# QUIKTRIP 4283

## SITE PLAN

1st Review  
Aurora Water  
Jenny Wynn  
jwynn@auroragov.org

QUIKTRIP 4283  
E-470 & EAST 64TH AVENUE  
SITE PLAN  
COVERSHEET

QUIKTRIP 4283  
E-470 & EAST 64TH AVENUE  
SITE PLAN  
SITE PLAN

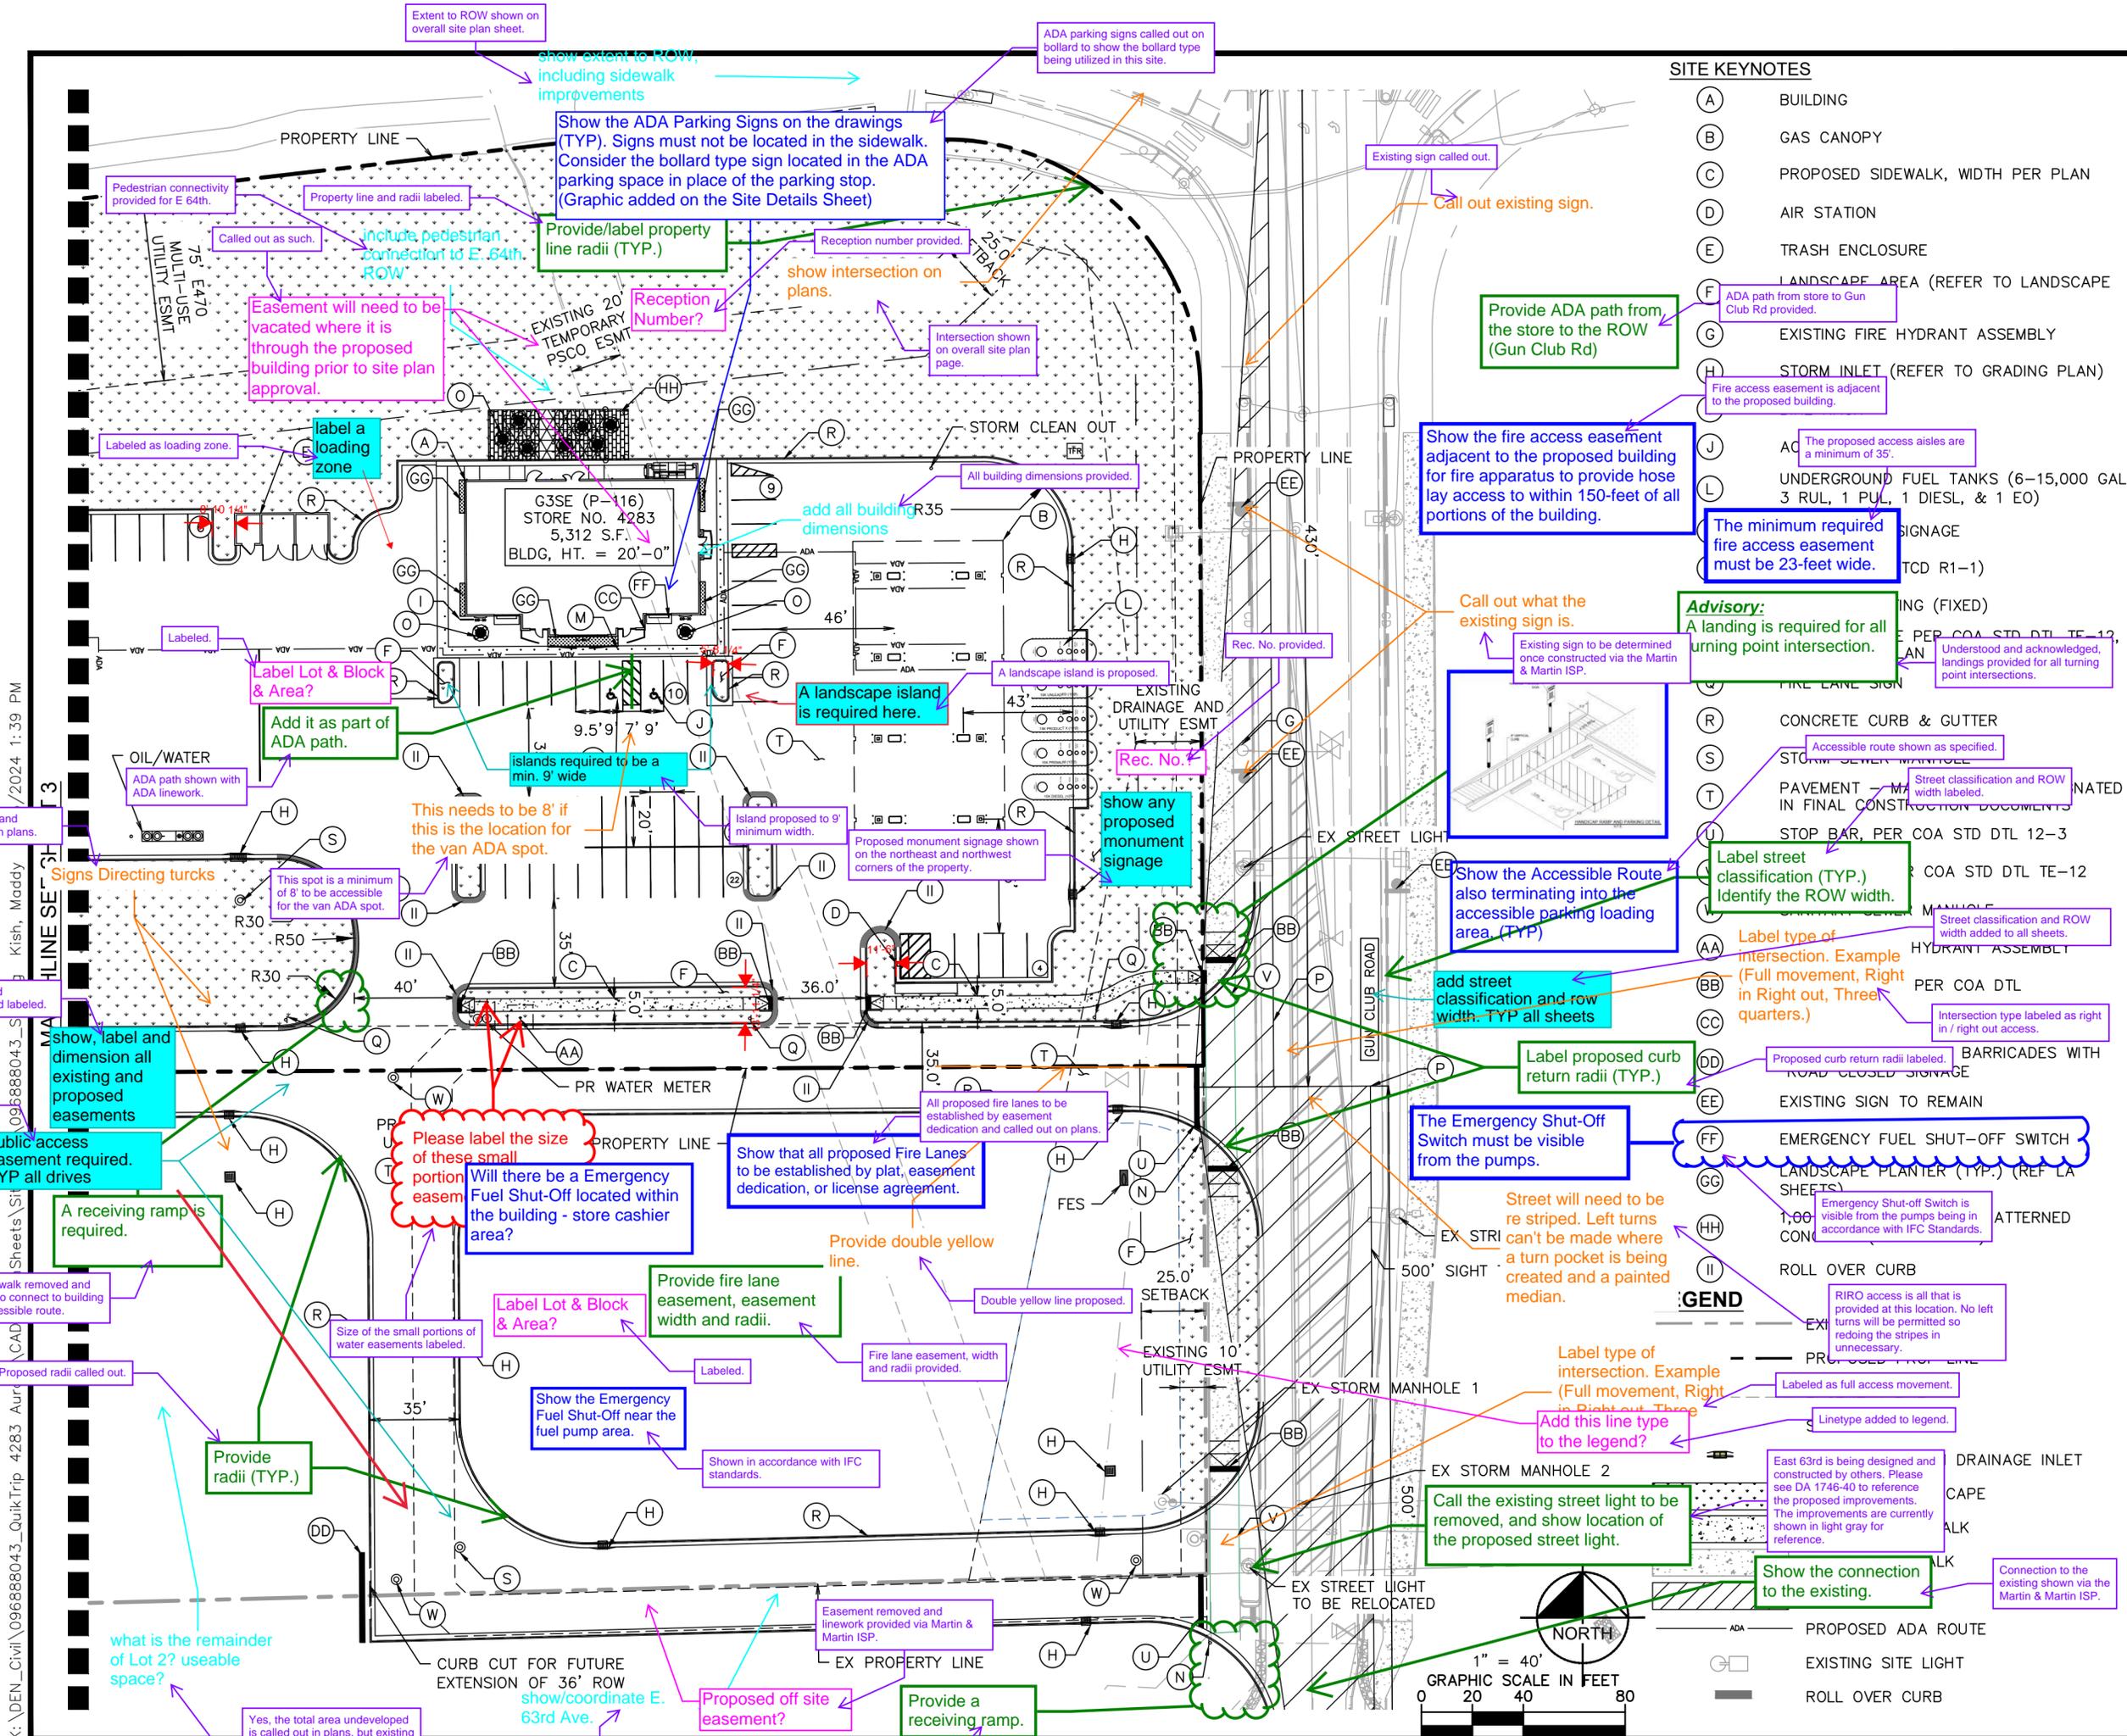
Show E. 64th Avenue improvement adjacent to the northern border of the site per the public improvement plan. If another site plan provide this improvement on the E. 64th Avenue is required before issuance of TCO.

Show the Emergency Fuel Shut-Off near the fuel pumps, one for each canopy.

PROVIDE AN OVERALL SITE PLAN THAT INCLUDES LOT 2/ACCESS

E. 64th Avenue improvement shown in overall site plan page.

Overall site plan provided.

**QUIKTRIP 4283**  
E-470 & EAST 64TH AVENUE  
SITE PLAN  
VEHICULAR CIRCULATION PLAN

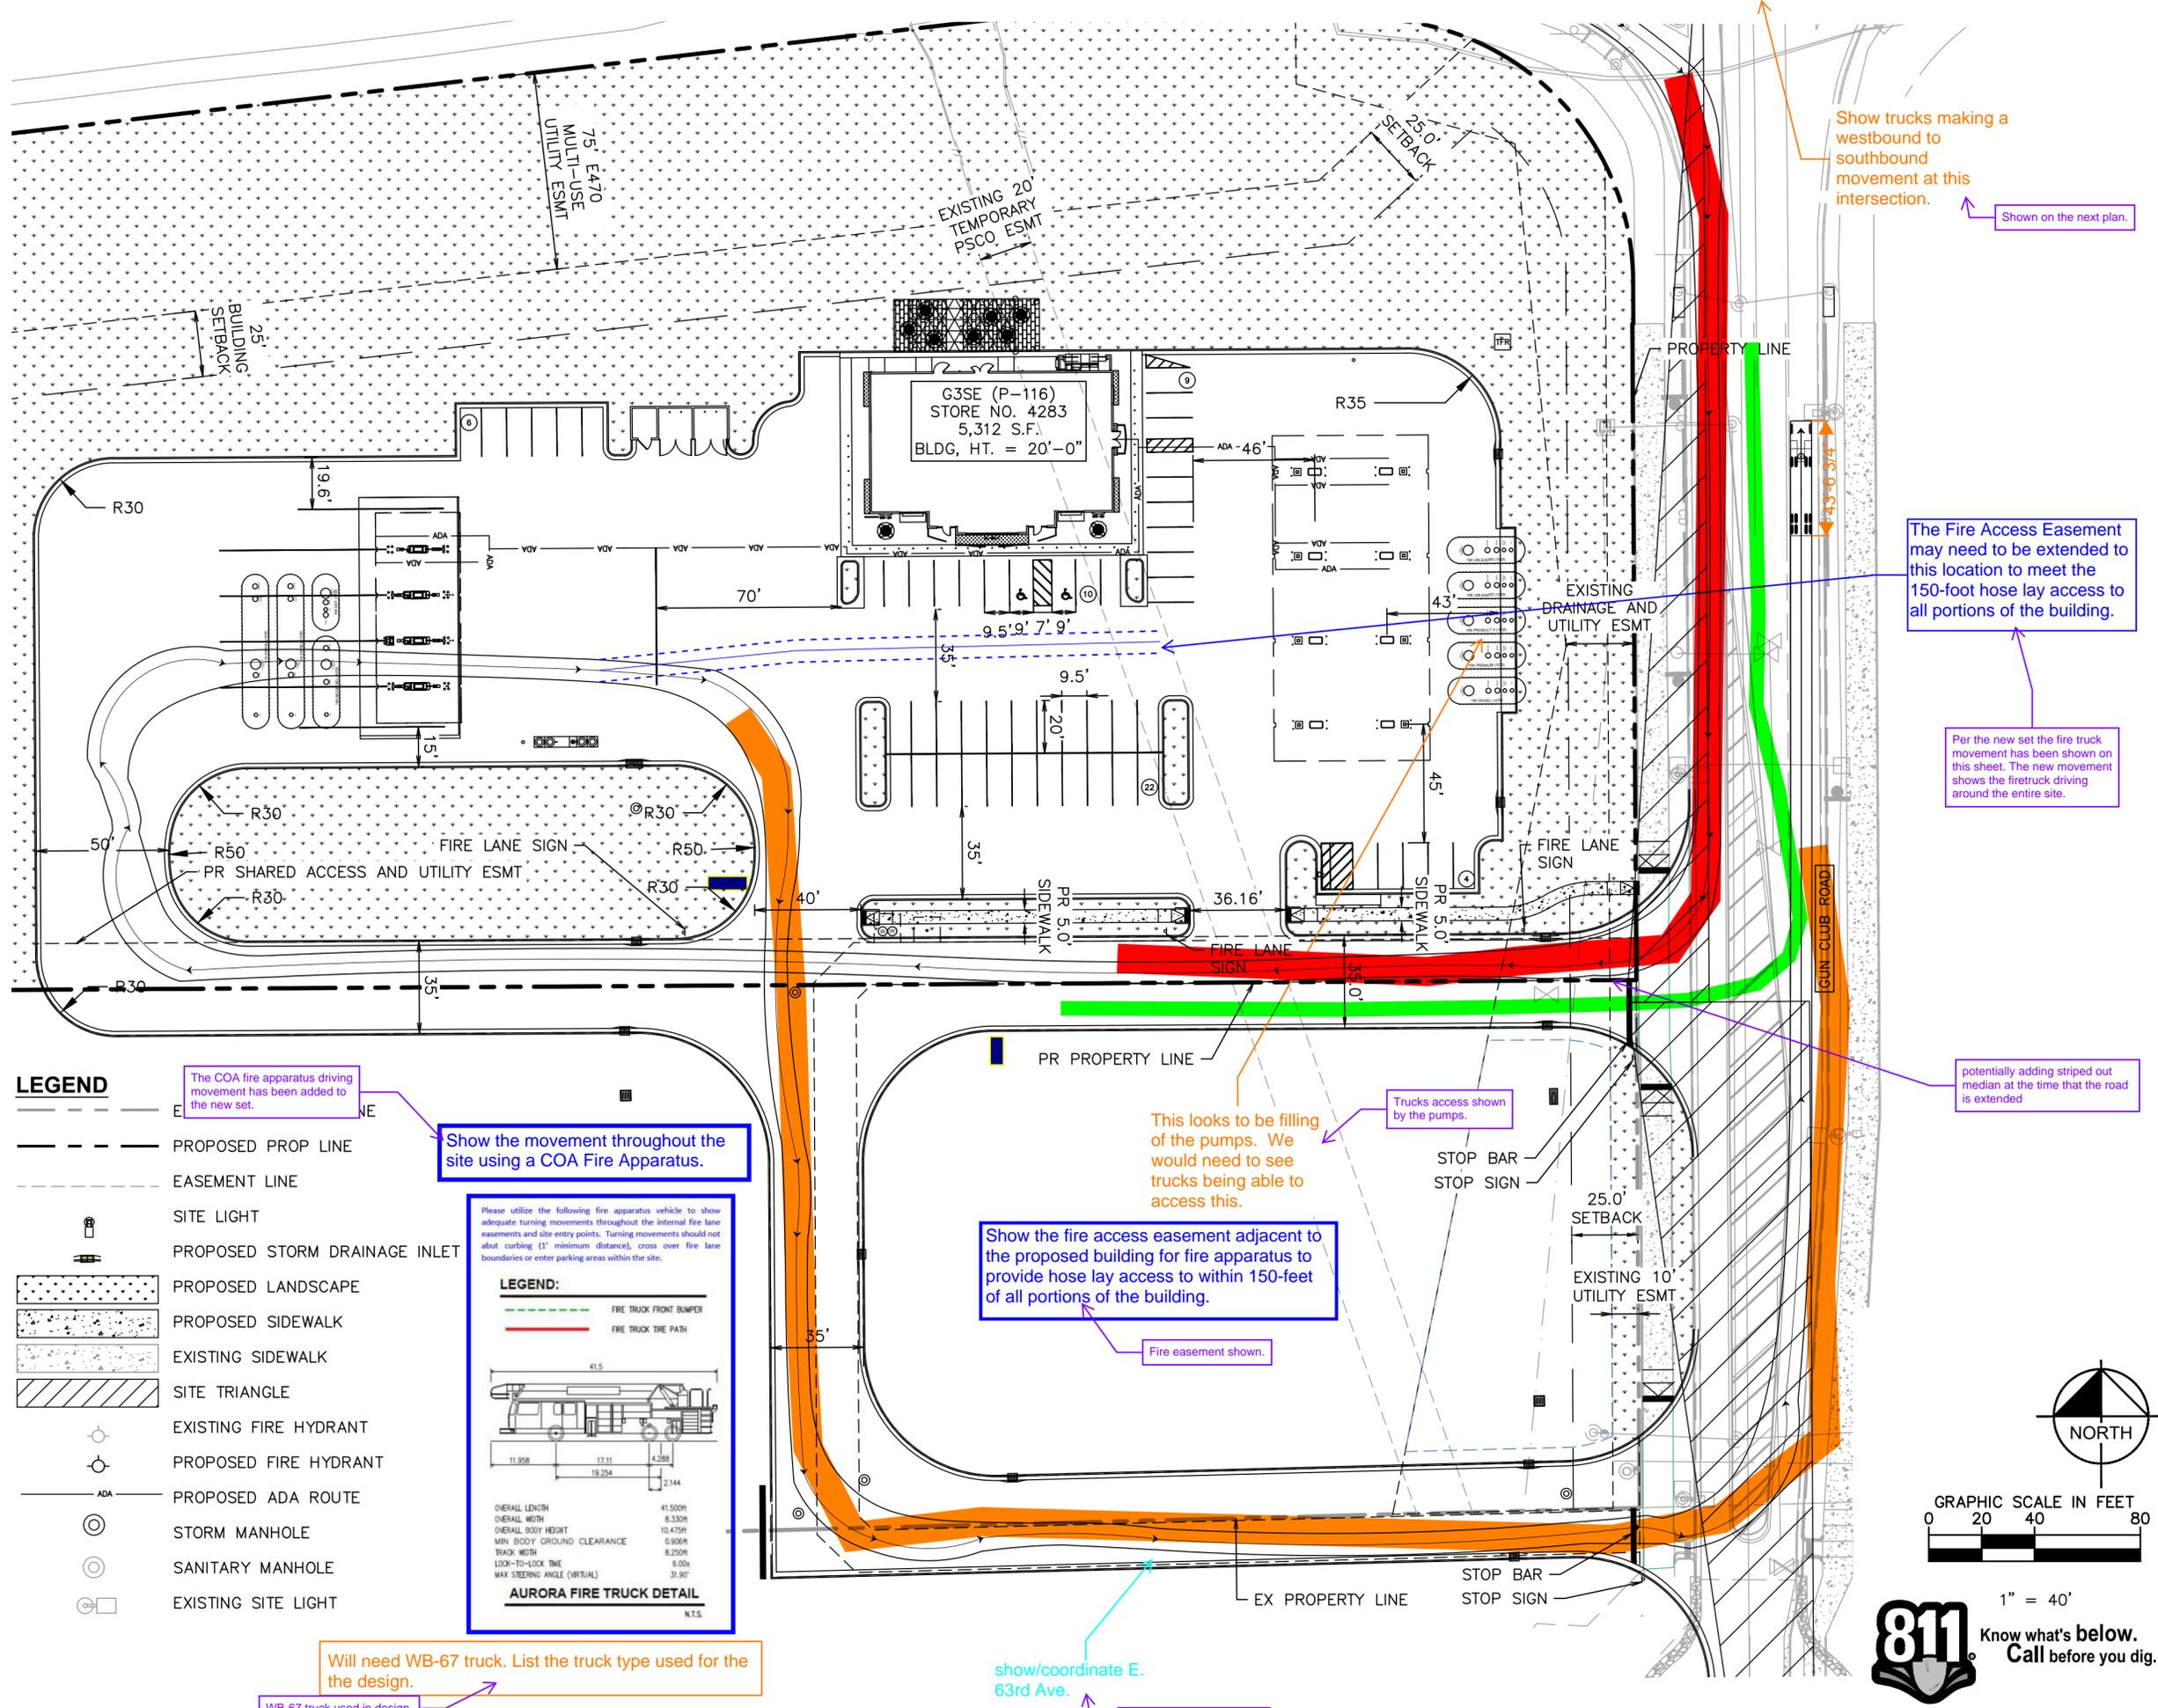
Show the movement throughout the site using a COA Fire Apparatus.

Show the fire access easement adjacent to the proposed building for fire apparatus to provide hose lay access to within 150-feet of all portions of the building.

Show trucks making a westbound to southbound movement at this intersection. Shown on the next plan.

show/coordinate E. 63rd Ave.

The COA fire apparatus driving movement has been added to the new set.

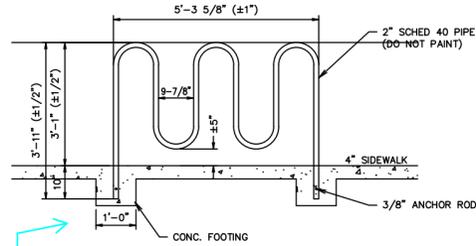
Show the parking stops, location of the Accessible Parking signs, or bollard type parking signs in place of the parking stop. (TYP all sheets)

Shown in plans and details shown.
